## Application for Licence

<b>Licence Number</b>	L9444/2024/1
<b>Applicant</b>	Matters Enterprises Pty Ltd Trading as RUBBERGEM
<b>ACN</b>	090 053 384
<b>File number</b>	DER2024/000271 & APP-0026144
<b>Premises</b>	Rubbergem 1228 & 1250 Rockingham Road (via Henry Street, off Hope Valley Road)  Legal description Lot 18 and Lot 19 on Diagram 19020 Lot 18 Certificate of Title Volume 1193 Folio 623 Lot 19 Certificate of Title Volume 1838 Folio 629 As defined by the coordinates in Schedule 2 of the licence
<b>Date of report</b>	7 October 2025
<b>Decision</b>	Licence granted

**Figure 4: BAL contour map with the red area denoting BAL-Flame Zone rated bushland.**

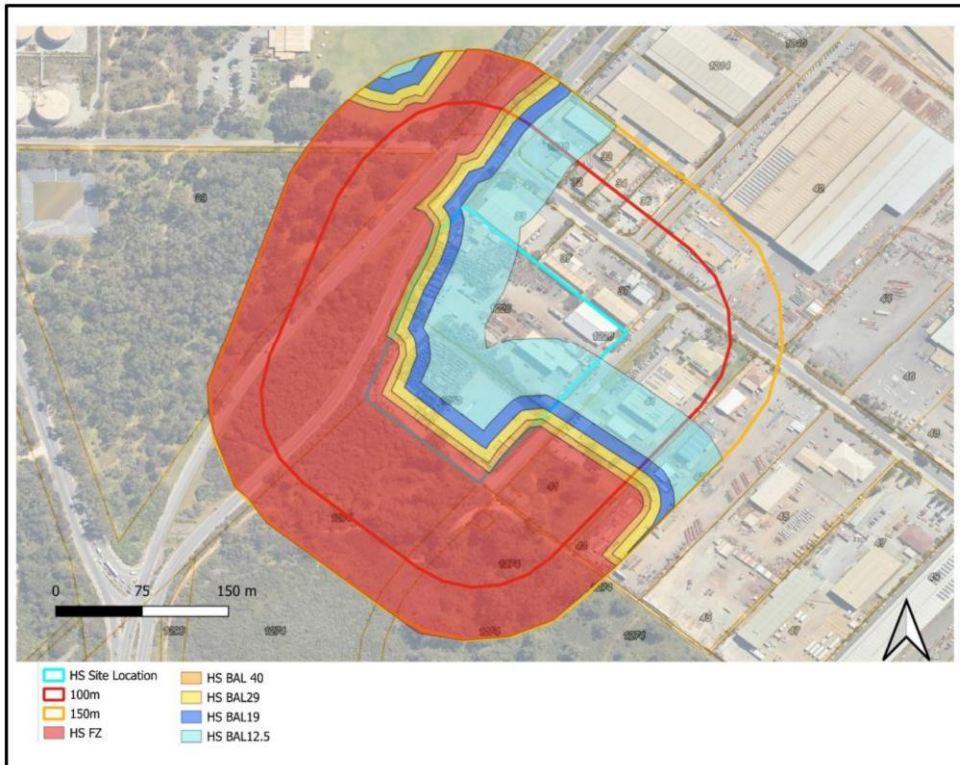
The BAL assessment has determined this area to have a BAL Flame Zone (FZ) rating. A BAL Flame Zone (FZ) is required to adhere to *State Planning Policy 3.7* bushfire prone legislation and poses a risk to the premises of ember attack, radiant heat and/or direct flame contact.

- An adequate separation distance between the bush fire prone area and the adjacent conveyor belt storage piles is required, to provide a separation distance which limits the likelihood of conveyor belt ignition due to fire spreading from adjacent bushland or adjacent premises.

**Figure 5: Arrangement of interconnected on-site soakwells**

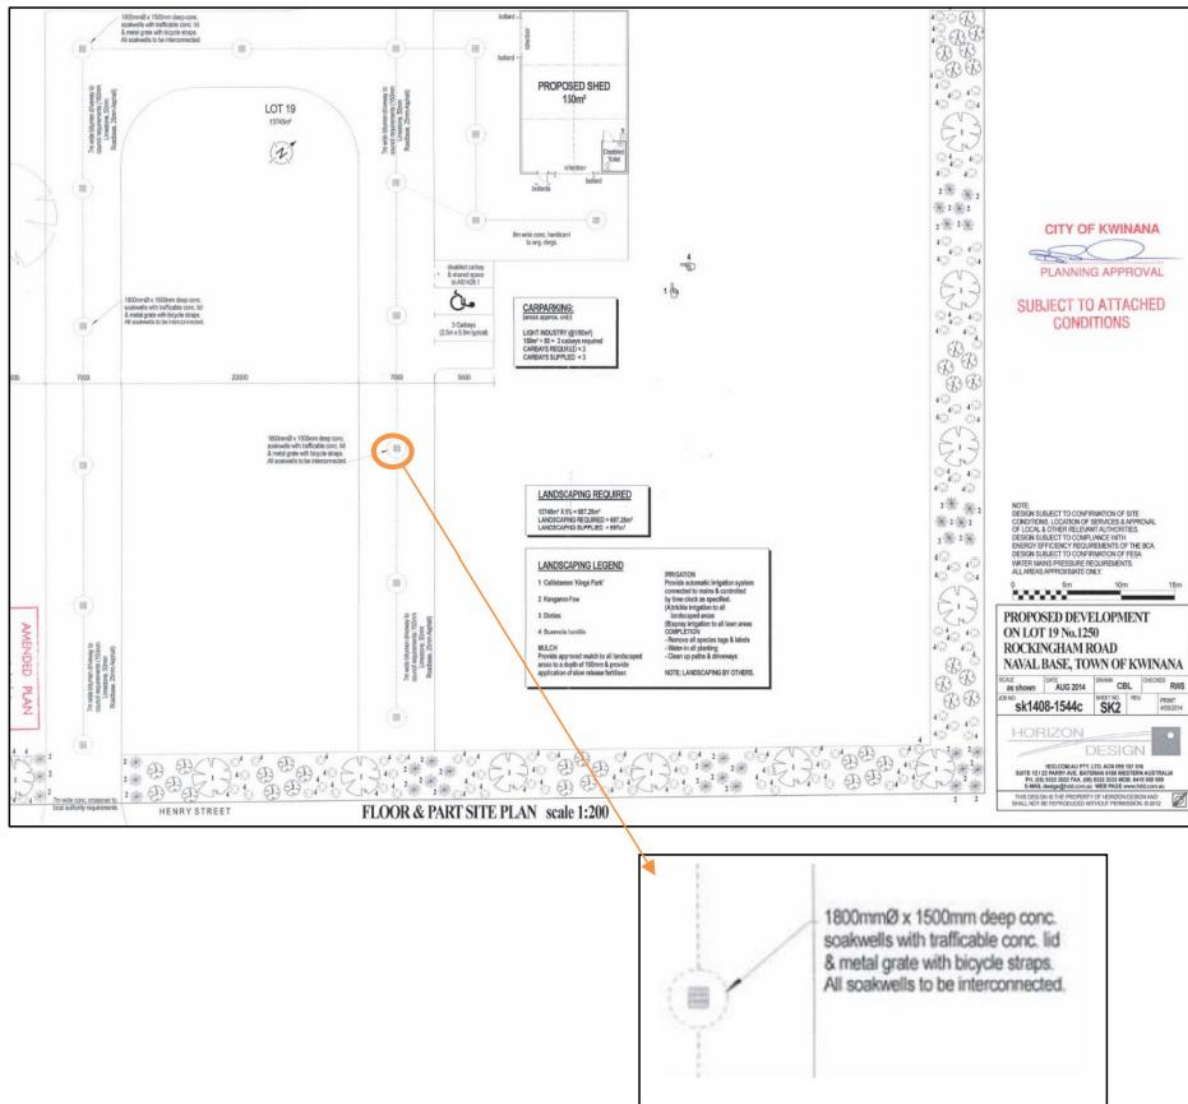
There is no bunding or containment surrounding the on-site hardstand areas. The site slopes downwards in a southerly direction; therefore, firefighting water run-off will move predominately towards unlined sumps and drains within and adjacent to the premises and to the bushland area and wetland adjacent to the southern premises boundary (refer to Figure 6). Given existing site drainage and infrastructure, firefighting water run-off is likely to infiltrate into soil with the potential to seep into groundwater located approximately 10 to 12 mbgl.

- Other provisions to prevent contaminants present in firefighting water entering soil and groundwater via soakwells, sumps, drains and exposed bare soil, have not been proposed. In summary, proposed controls fail to demonstrate that firefighting water will not enter the stormwater drainage system that directly infiltrates to soil adjacent to, and beneath the premises and regulatory controls are required to ensure firefighting water is contained within the premises.

**Figure 8: Tyre crumb storage area and additional land acquired**

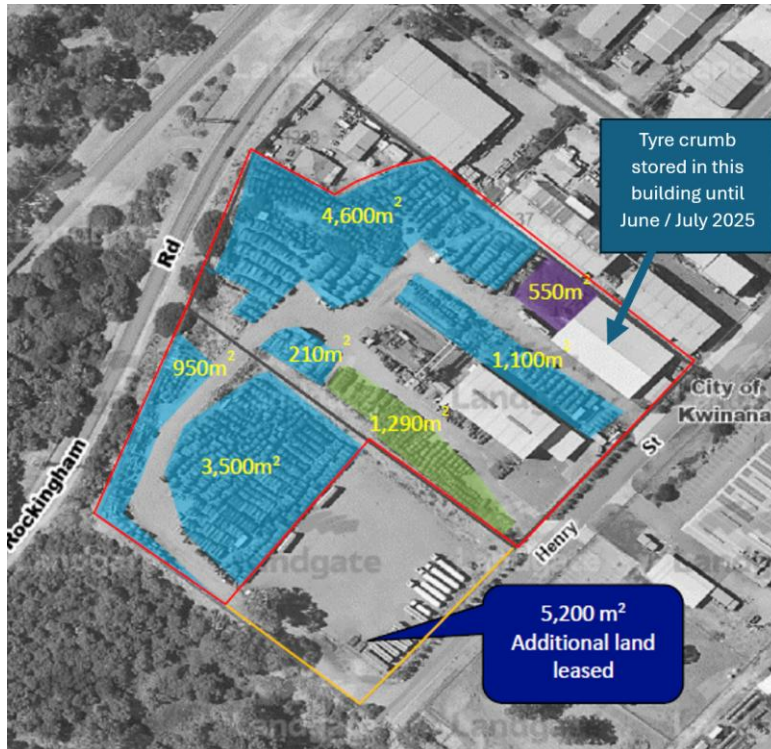
- Approximately 30 tonnes of rubber crumb (30 bulka bags of 1m<sup>3</sup>), is stored within the equipment store building, which is a single fire compartment of 800 m<sup>2</sup> in size. According to DFES GN02, where combustible material exceeds 10 tonnes and the building's single fire compartment floor area exceeds 2000 m<sup>2</sup>, smoke and heat ventilation as well as sprinkler protection is required within the building. As the floor area of both the warehouses is less than 2000 m<sup>2</sup>, venting and sprinkler protection is not required based on DFES GN02 guidance.

- The newly leased portion of Lot 19 (as shown in Figure 8) is compacted gravel and is therefore not a sealed hardstand, providing a pathway for firefighting water to enter the soil (and potentially groundwater) and the wetland to the south of the premises, increasing the likelihood of firefighting water reaching soil and groundwater.

As the newly leased portion of Lot 19 (as shown in Figure 8) is compacted gravel and is therefore not a sealed hardstand, regulatory controls are required to prevent storage of rubber crumb or shredded rubber in this area due to the potential of shredded or crumbed rubber to spontaneously ignite in large stockpiles when exposed to heat. Additionally, stockpiles of shredded or crumbed rubber are difficult to move and separate in the event of fire, whereas conveyor belts and rubber product (matting) can be moved to prevent fire spread to the unsealed area, enabling firefighting water to be contained within the sealed hardstand. It also enables the fire to be effectively extinguished and contained if the fire originates within the unsealed hardstand area.
